September 1, 2010
Subject: **Kennebunk**
State Pin No: 015098.00
Amendment No. 1

Make the following changes to the bid documents:

In the Plans, **REPLACE** the following Plan Sheets with the attached new Plan Sheets;
SHEET NUMBER 2 OF 48
SHEET NUMBER 5 OF 48
SHEET NUMBER 44 OF 48
SHEET NUMBER 45 OF 48

KENNEBUNK BRIDGE MOUSAM RIVER YORK COUNTY KENNEBUNK ESTIMATED QUANTITIES AND GENERAL NOTES	SHEET NUMBER 2
	OF 48

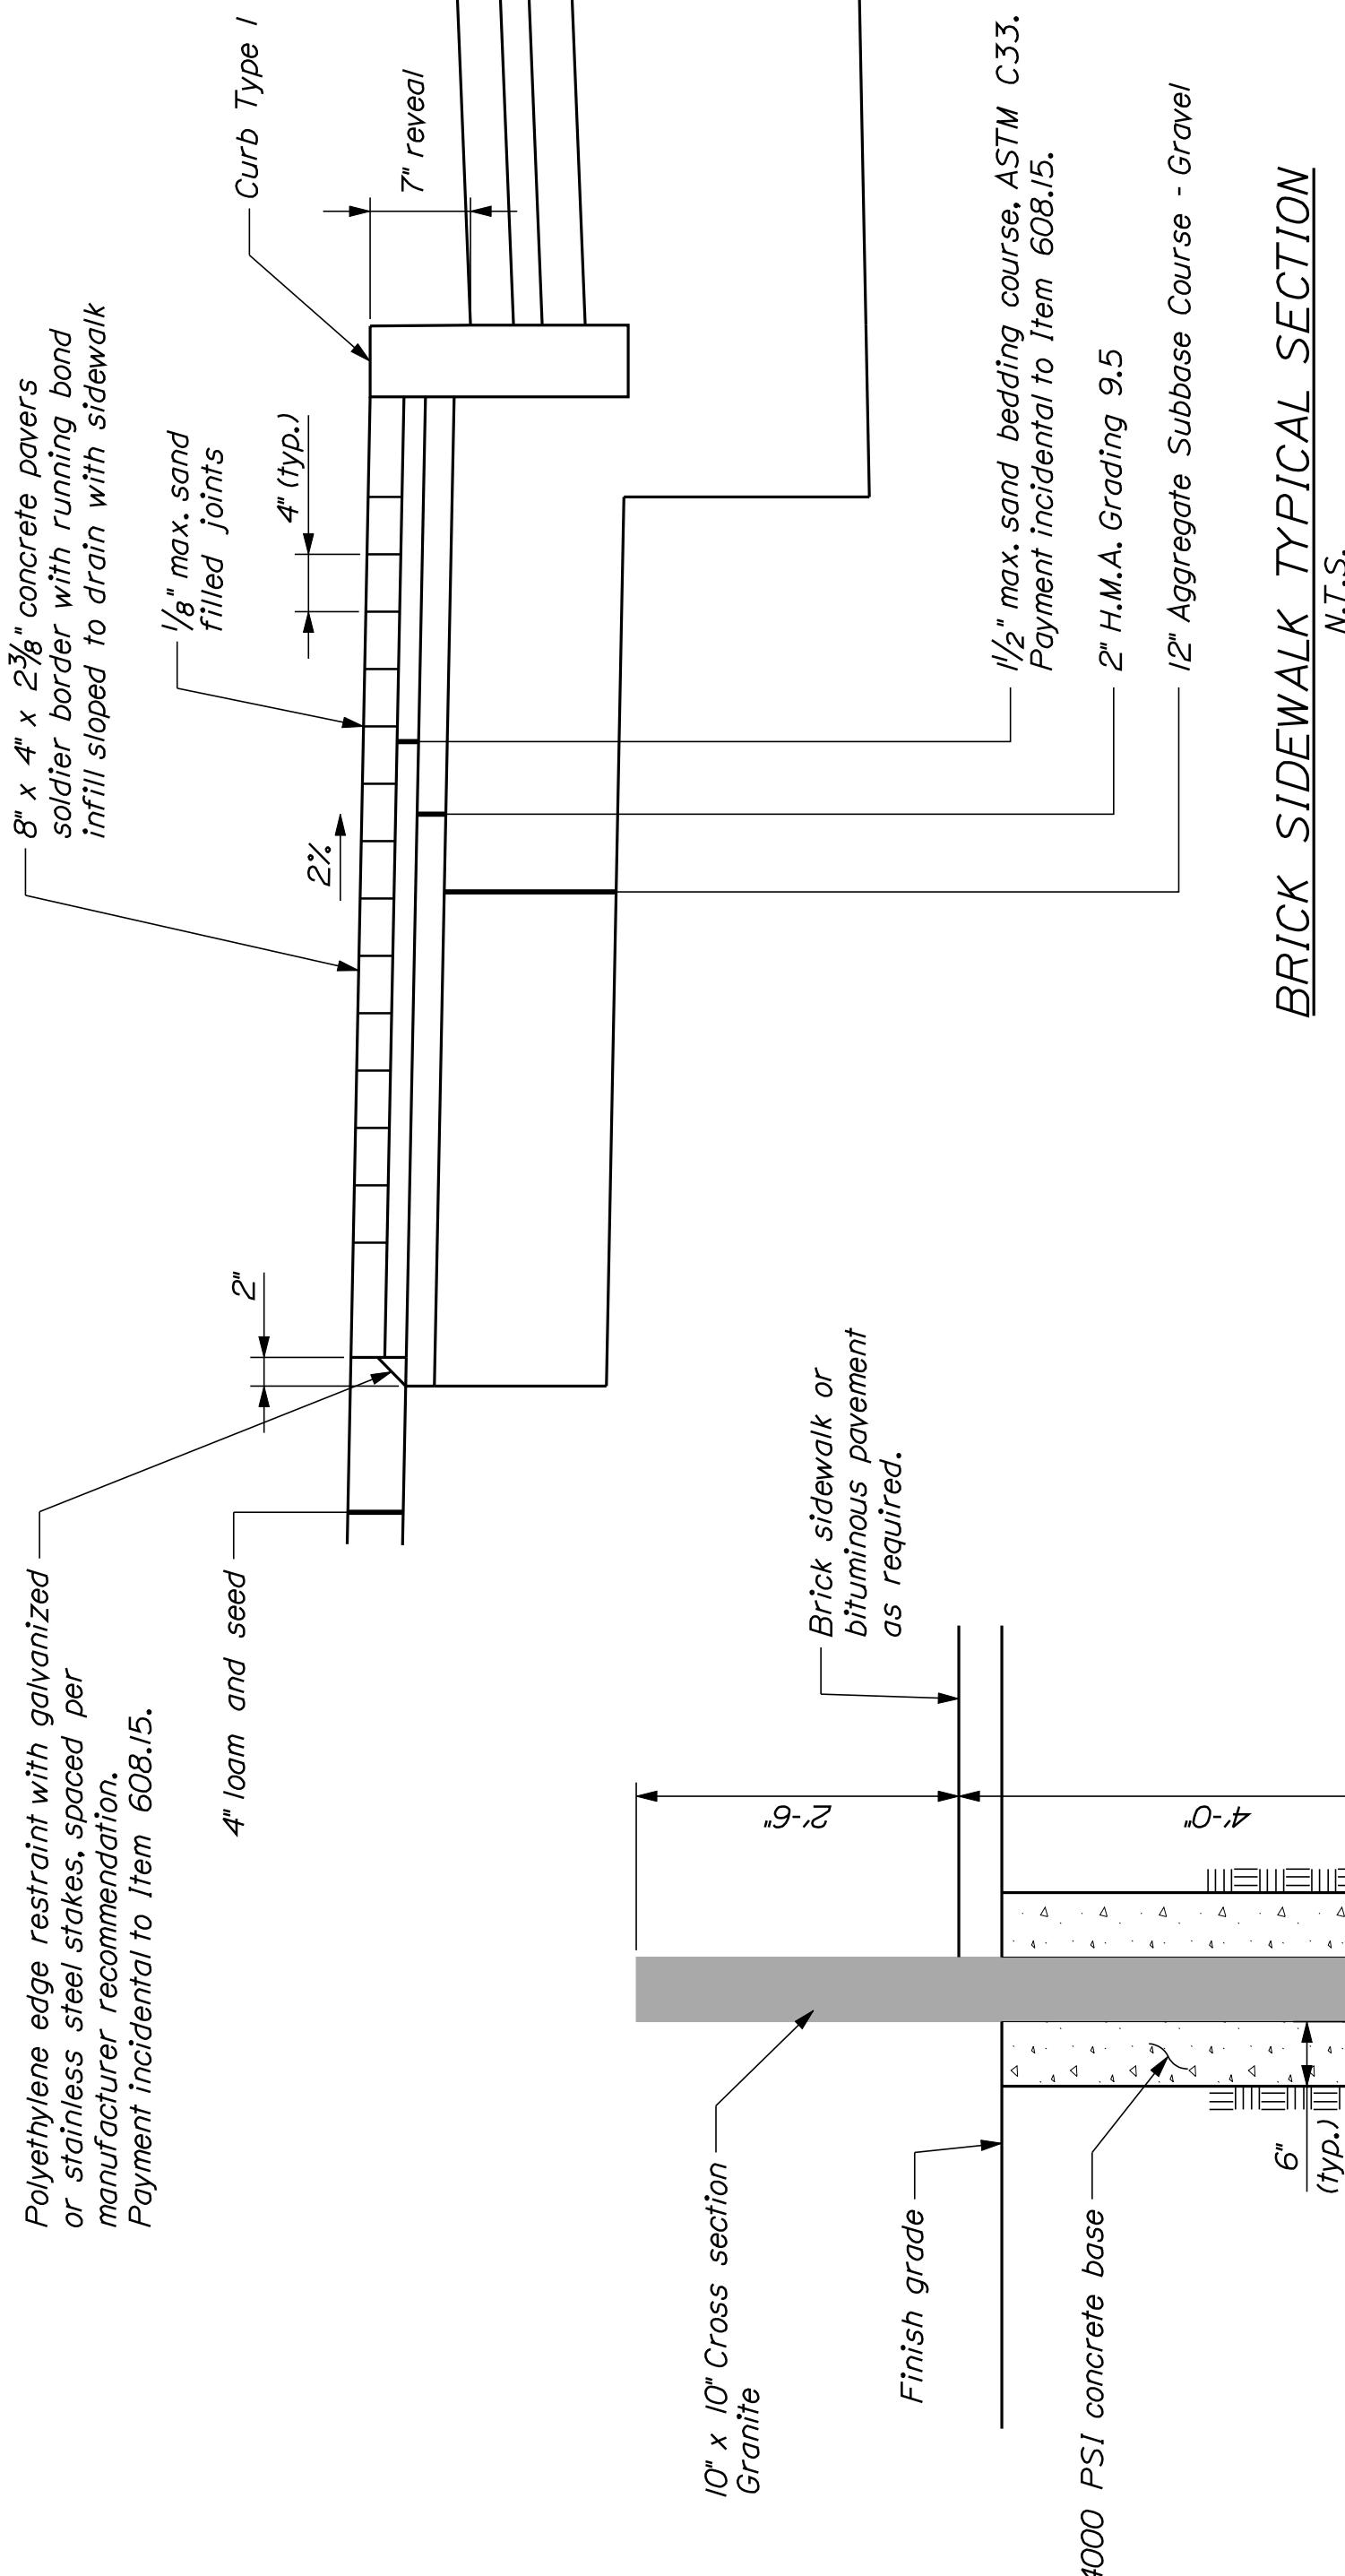
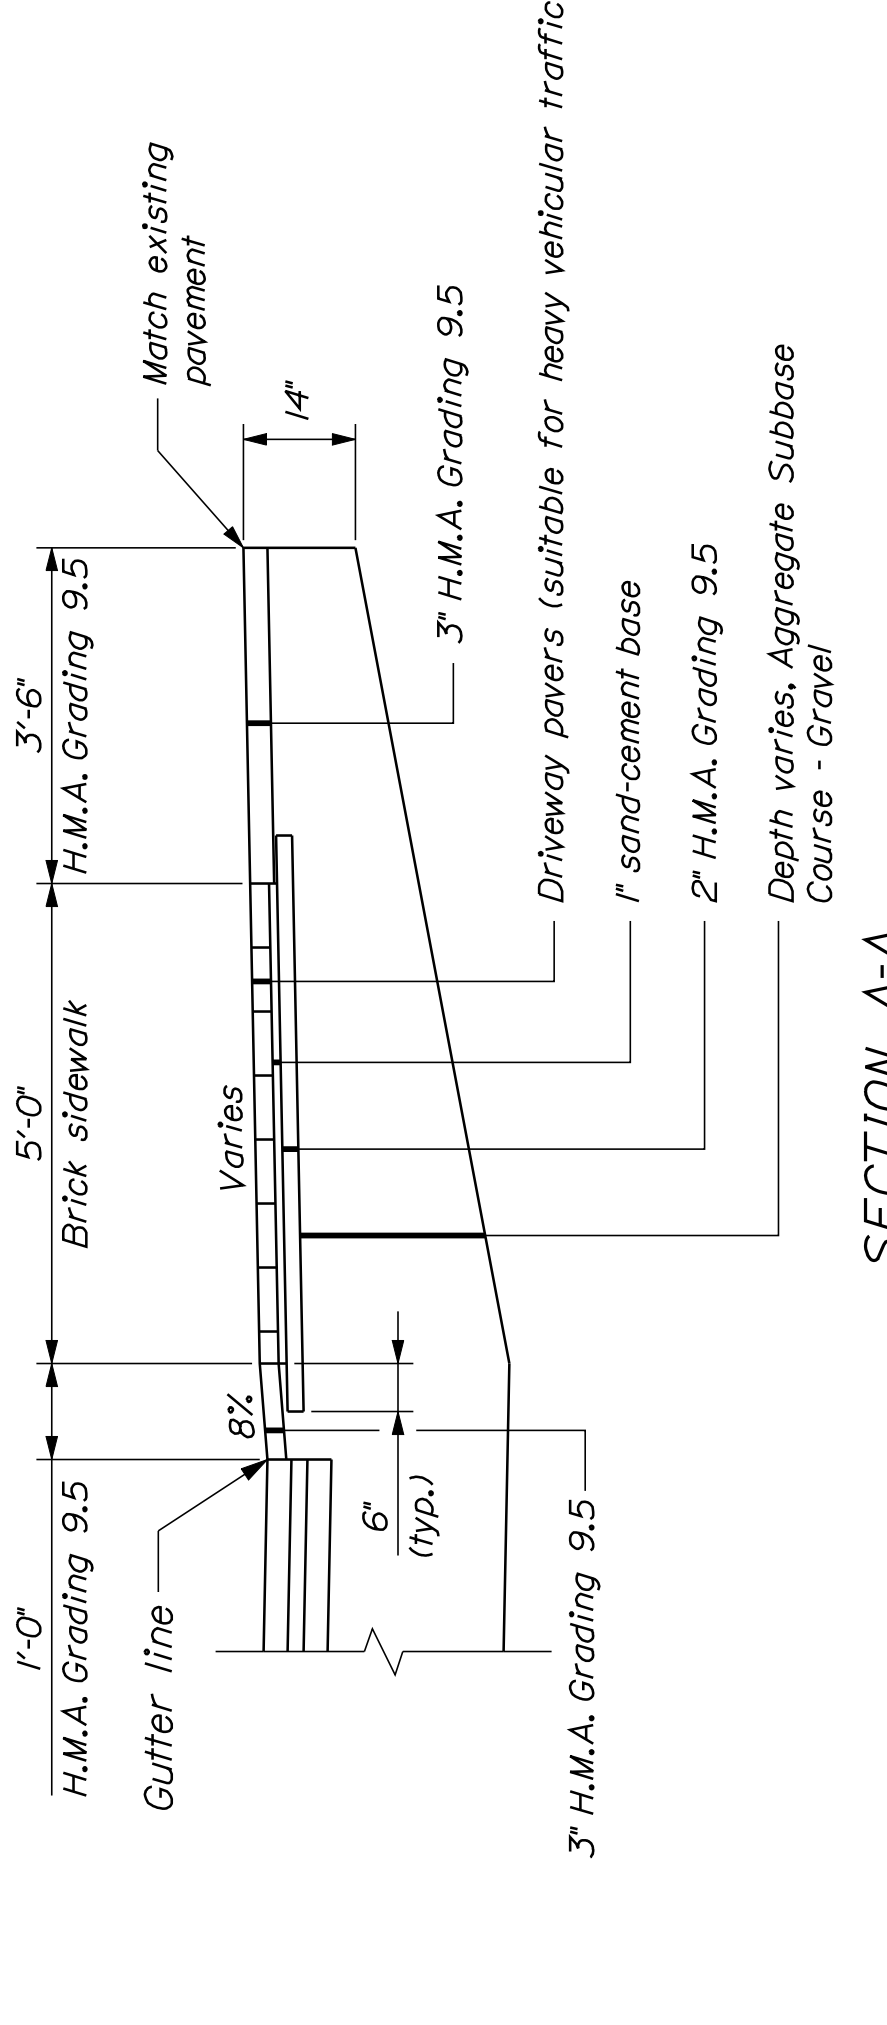
We recommend that an Addendum be issued to the project documents to update the notes and pay items based on the information contained herein. The recommended modifications to include in the Addendum are listed below, with new note text underlined:

2. **Note 2** – Modify as follows: “For bid purposes, the sluiceway removal limits should be assumed to be a 14-foot wide area within the limits defined above, extending from 25’ Lt. to 26’ Rt. and from the ground surface to a depth of 21 feet. The removal may also include loose soil and/or voids adjacent to the sluiceway structure as defined by the Geotechnical Engineer.”
3. **Note 3** – Add a second sentence as follows: “For bid purposes, assume 70-foot long temporary earth support structures will be installed at 25’ Rt. and 25’ Lt.”
4. **Note 7** – Change current Note 7 to Note 8 and add the following: “Additional sinkhole information and recent geophysical data is presented in the geotechnical memorandum titled, “Summary of South Approach Sinkhole Issues, Kennebunk Bridge,” dated August 24, 2010, which may be accessed at the MaineDOT web address.”

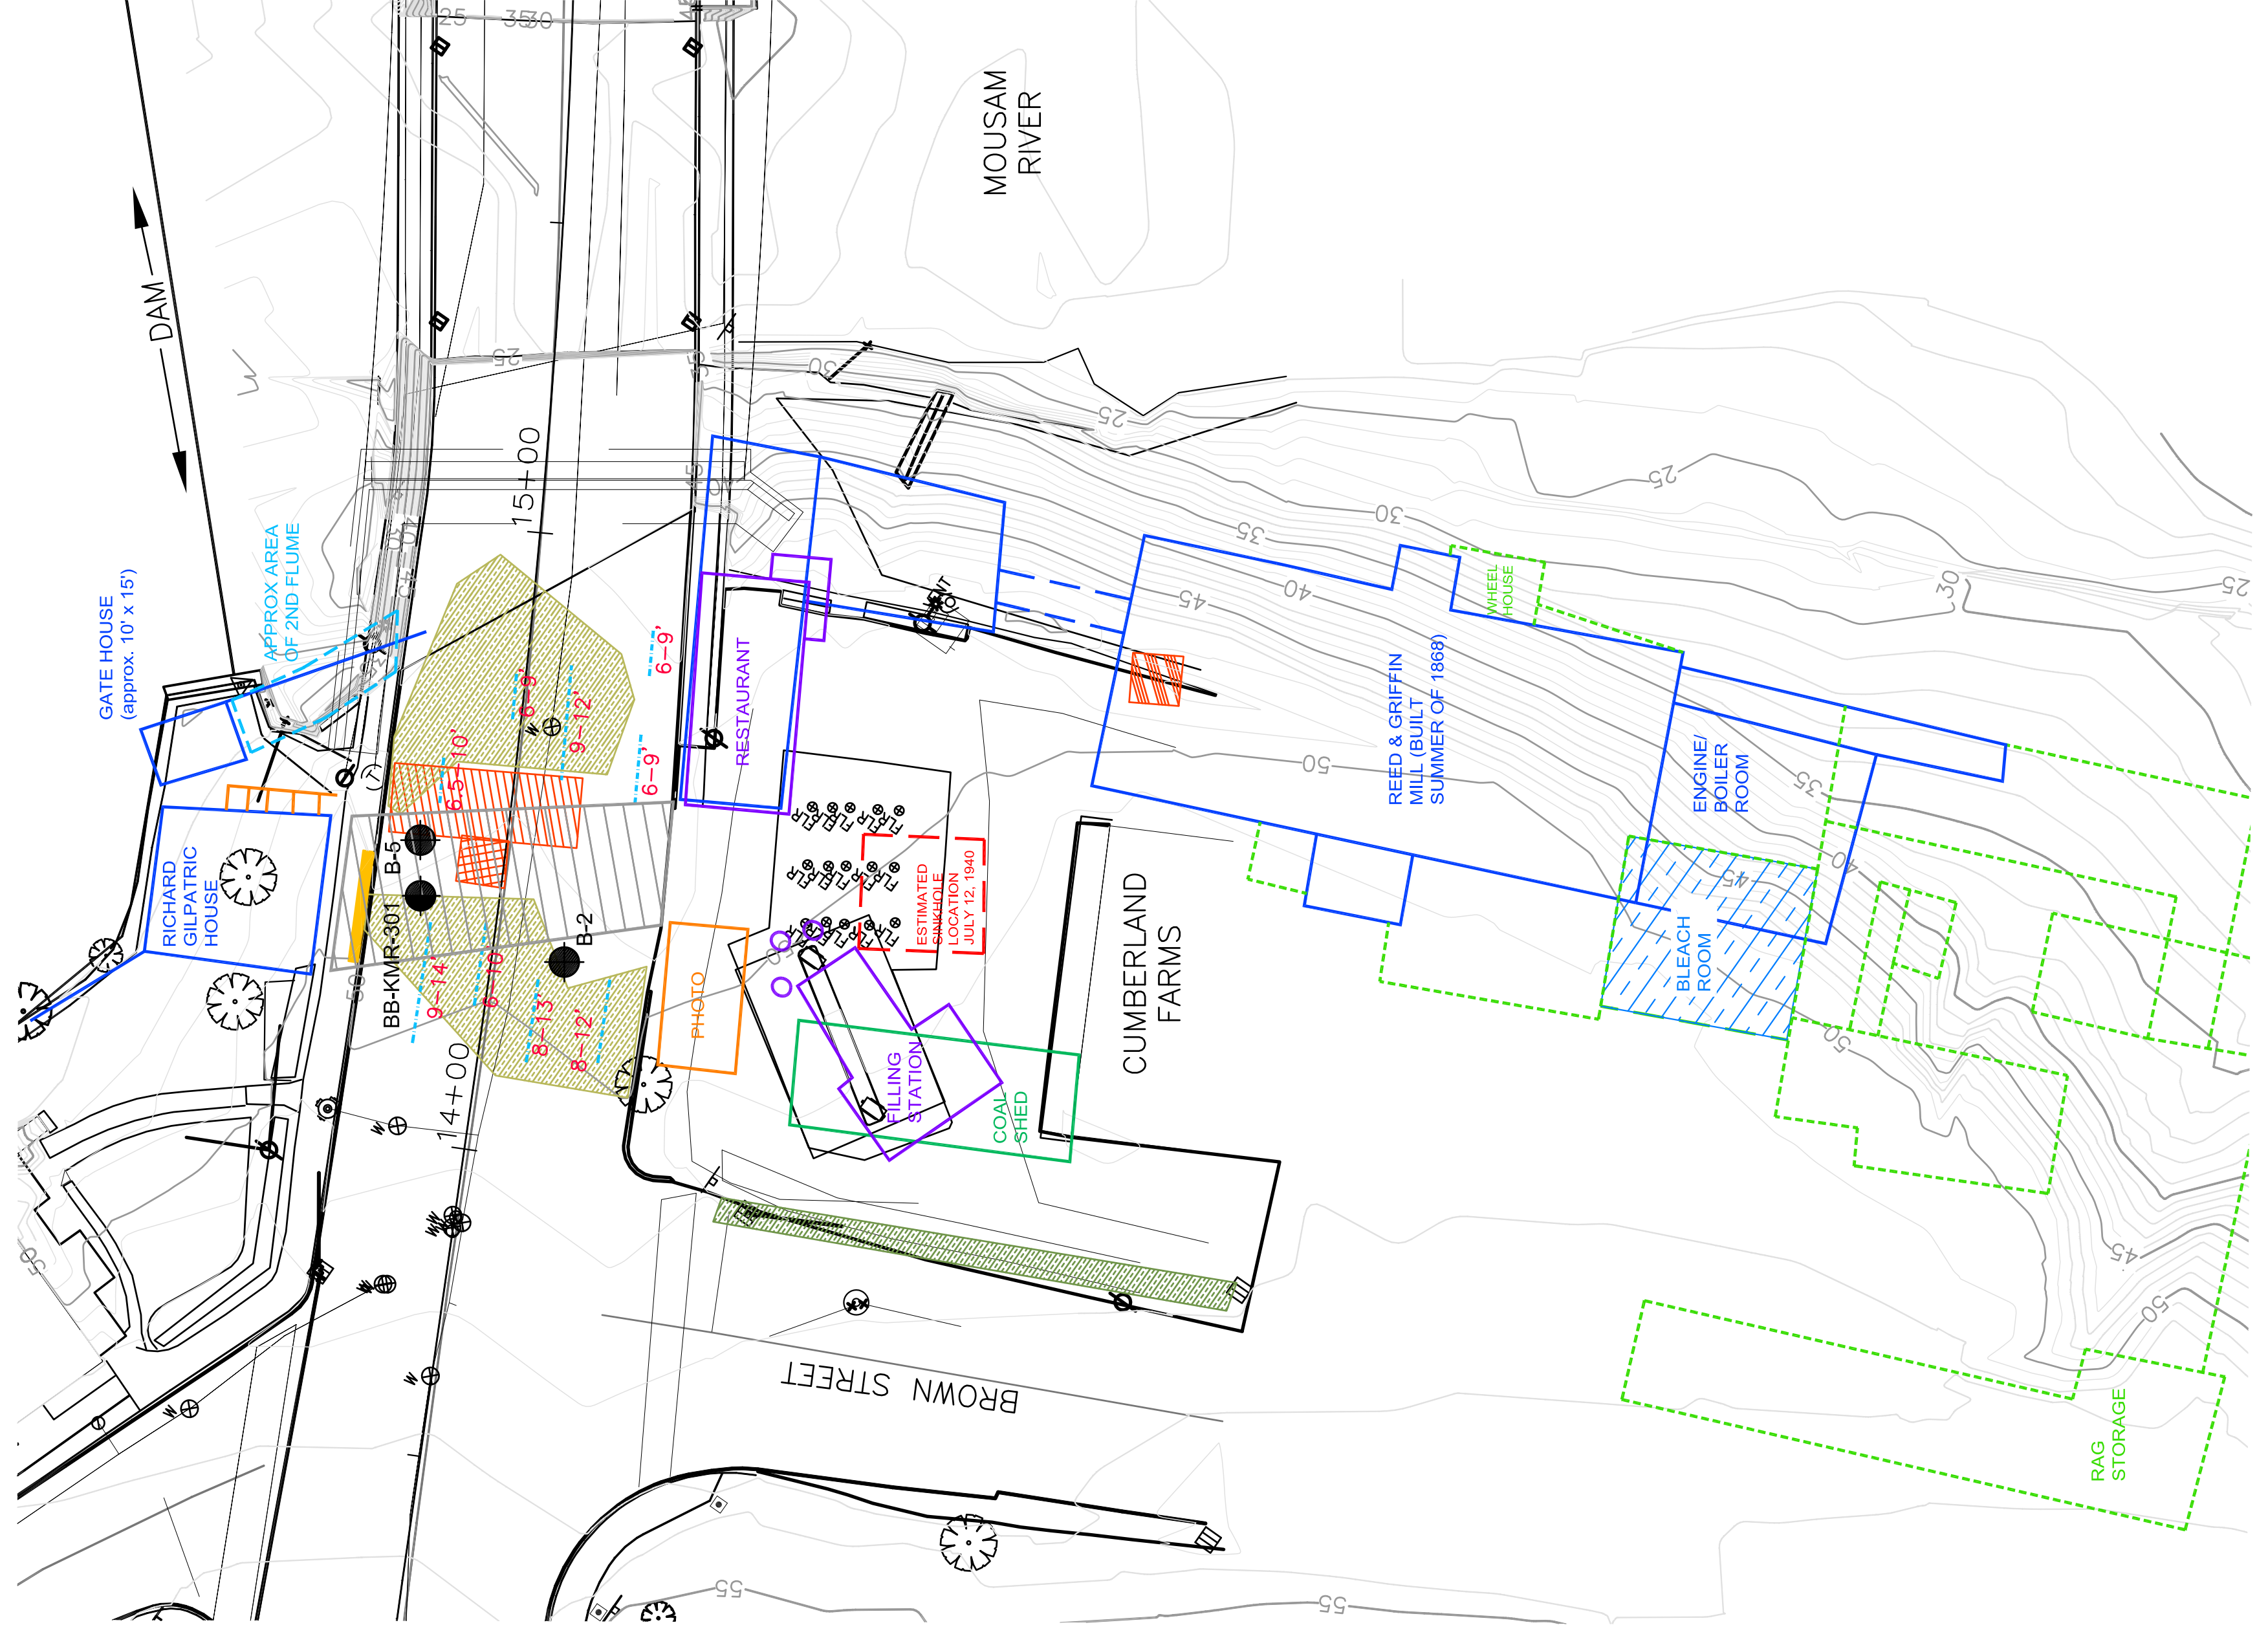
- Based on the available data, the 14-foot wide sluiceway was most likely located within the area bounded by Sta. 14+25 to 14+51 at 25' Lt. and Sta. 14+37 to 14+60 at 26' Rt. In GZA's opinion, the practical limits of removal are from 25' Lt. to 26' Rt. These plan limits are shown on **Figure 1**.

- Data generated from the geophysical survey in 2004 do not identify likely sluiceway limits. However, the GPR results were indicative of settlement or filled sinkholes in the vicinity of the sluiceway. These areas are identified on **Figure 1**.
